# TERRA ASSOCIATES, Inc.

May 22, 2023  
Project No. T-5915-3

Subject: Response to Comments  
Geotechnical Report Addendum  
Wesley Homes Expansion  
Puyallup, Washington

Reference: Geotechnical Report Addendum, Wesley Homes Expansion, Puyallup, Washington, Project No. T-5915-3, prepared by Terra Associates, Inc., dated December 29, 2022

Figure 10

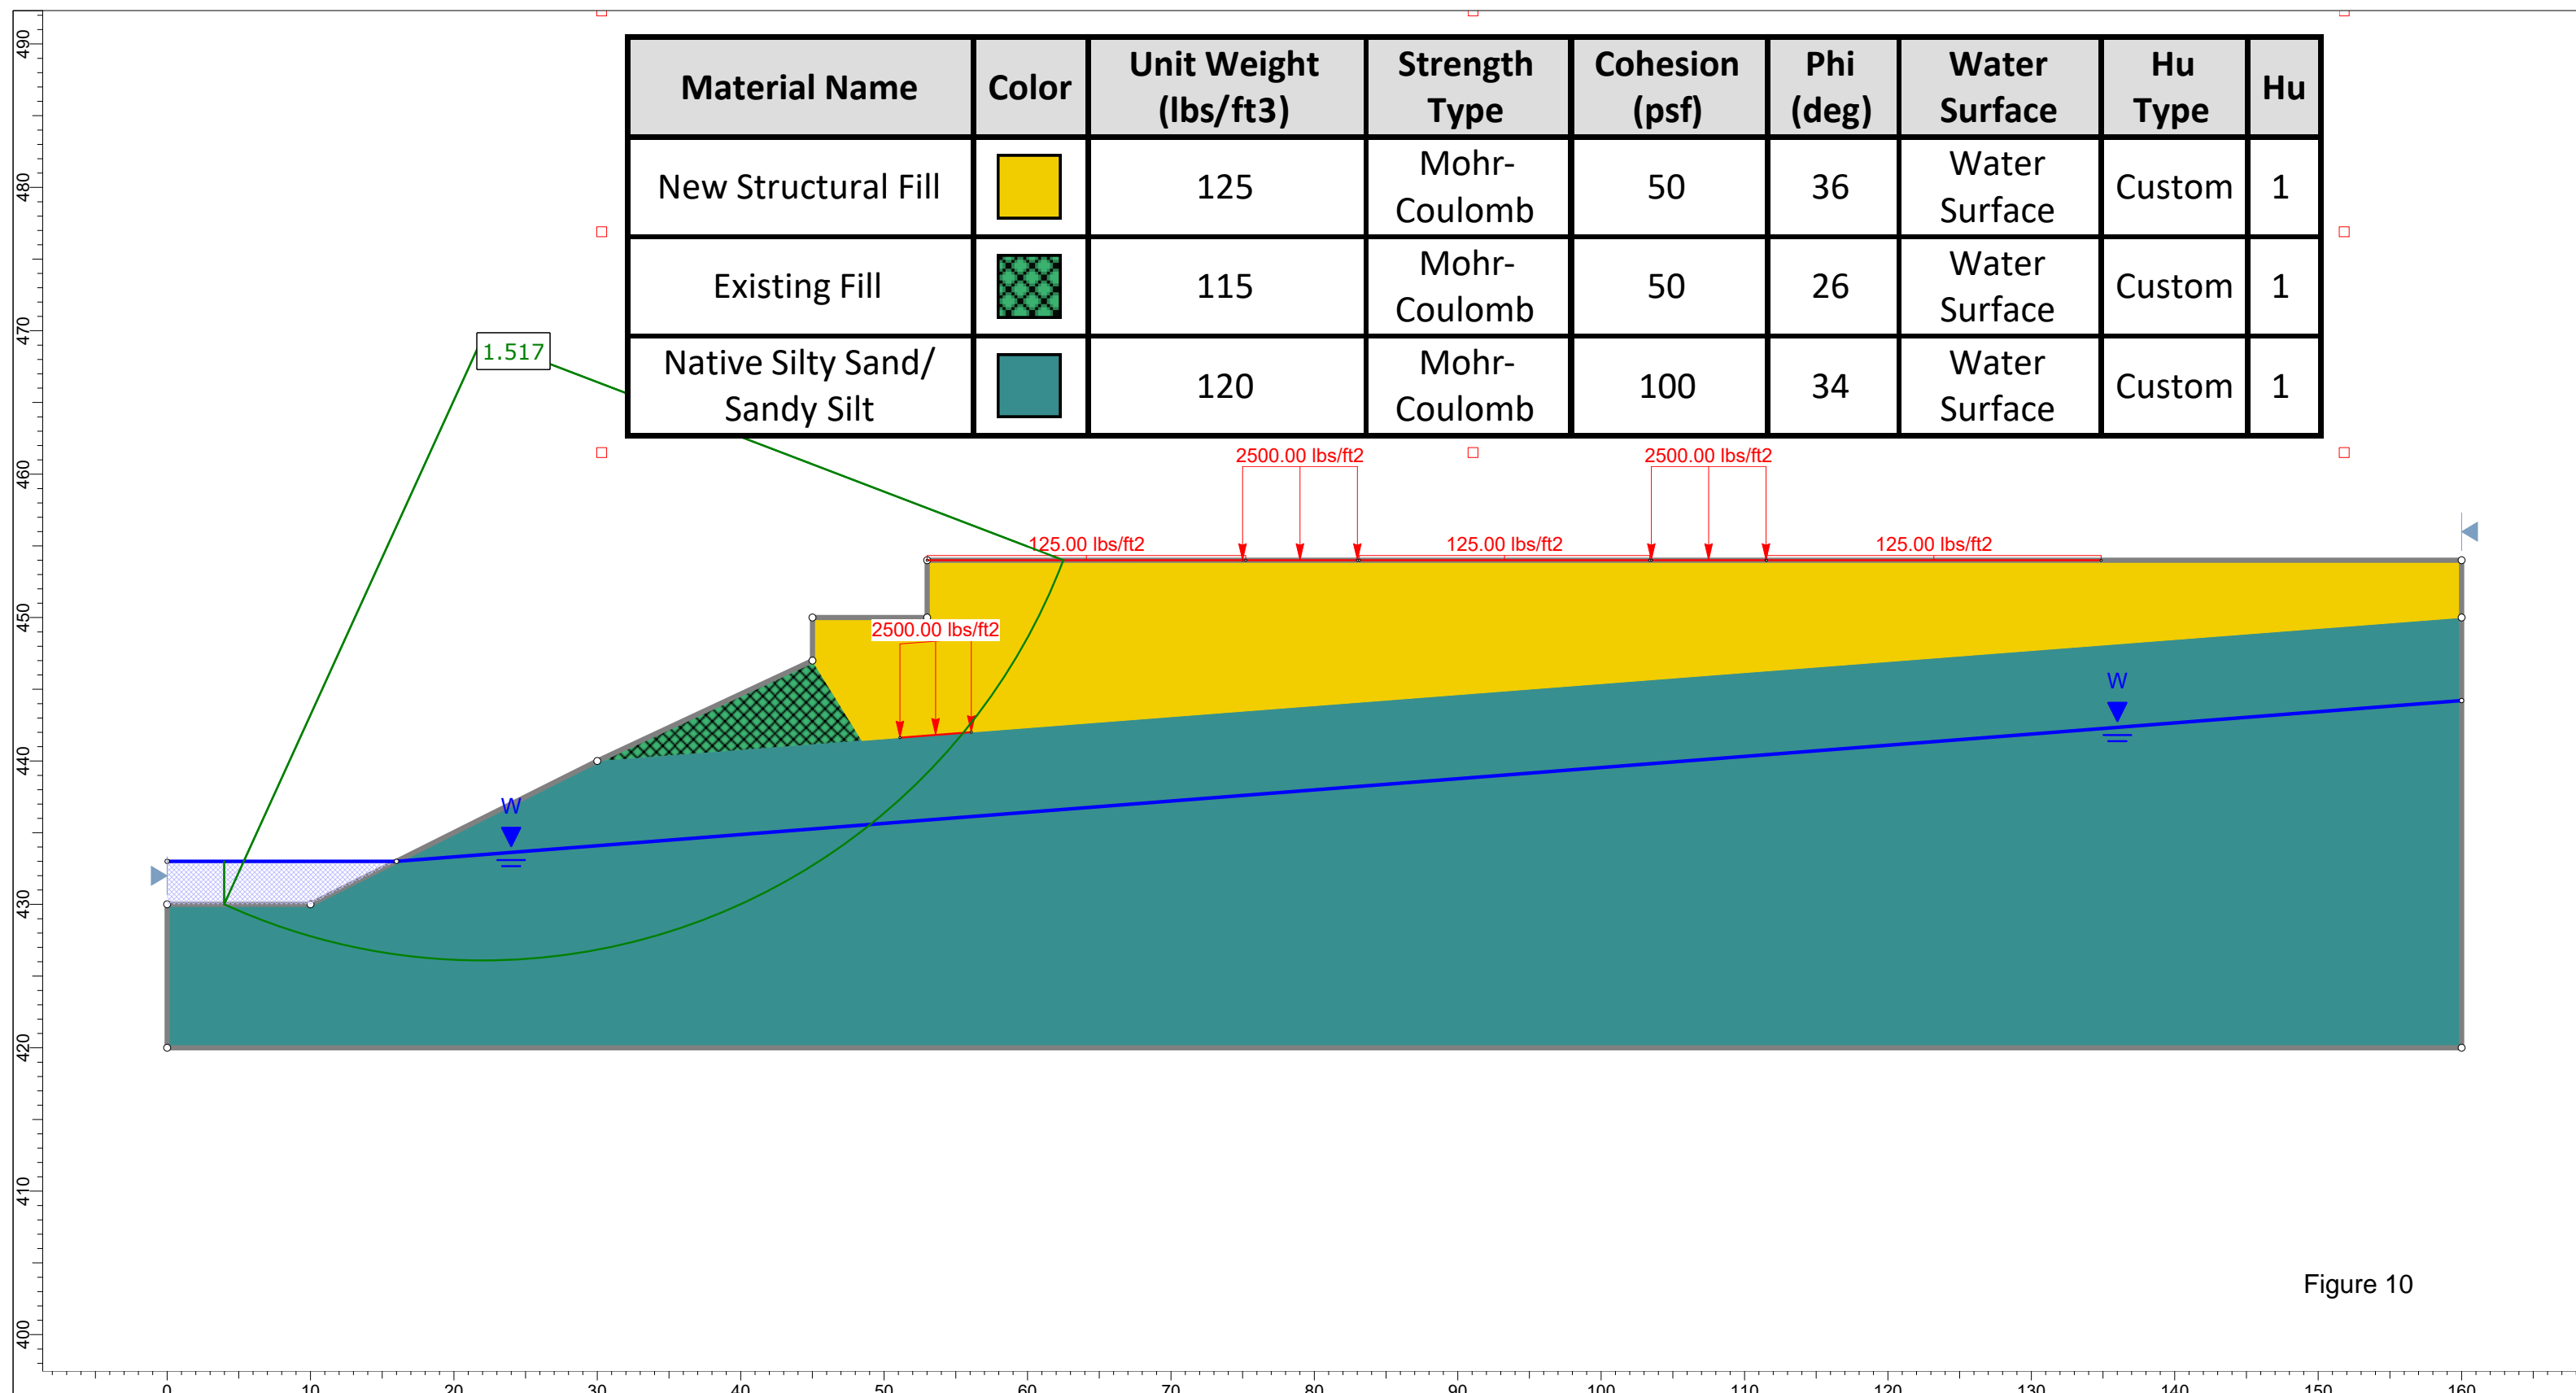
### ***PMC 21.06.1230 (2) (a)***

This section of the PMC requires that the proposed development in a landslide hazard area not decrease the factor of safety for landslide occurrences below 1.5 for static conditions and 1.2 for dynamic (seismic) conditions. To address this comment, we completed a stability analysis of a representative cross section of the slope that included grading and application of building loading from the proposed development. We also completed additional subsurface exploration to better define the limits of the unsuitable existing fill soils and underlying competent native soils. Supplemental test pit locations and test pit logs are attached as Figures 1 through 9. The location of the cross section analyzed is also shown on Figure 1.

We completed the stability analysis using the SLIDE2 computer program published by RocScience. Results of the analysis indicate that with the exiting unsuitable fill soils removed and replaced with structural fill placed and compacted in accordance with recommendations in our geotechnical report, the minimum safety factor under static conditions of 1.5 or greater would be met. A graphic of the cross section showing these results along with soil parameters used in the analysis is attached as Figure 10.
